Borough of Coopersburg

E. Station Ave. Streetscape Project

Questions & Answers from 3/15/18 Public Meeting

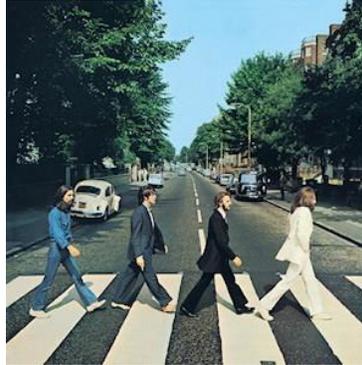
- **Question 3:** How can the Streetscape improve the safety of E. Station Ave. pedestrian / bicycle crossing at Rte. 309?

Answer 3: Yield to Pedestrian signs can be added on the signal mast arms at the intersection, and continental crosswalks can be provided for the 309 crosswalks to better catch the eye of drivers on Route 309. Continental crosswalks feature two-foot wide yellow or white painted stripes paired with a limit (stop) line setback from the crosswalk

to reduce vehicular encroachment into the crosswalk. The crosswalks alert motorists that they are approaching a pedestrian zone and are widely considered more safe than pedestrian crossings marked by two thin lines currently connecting the corners this intersection.
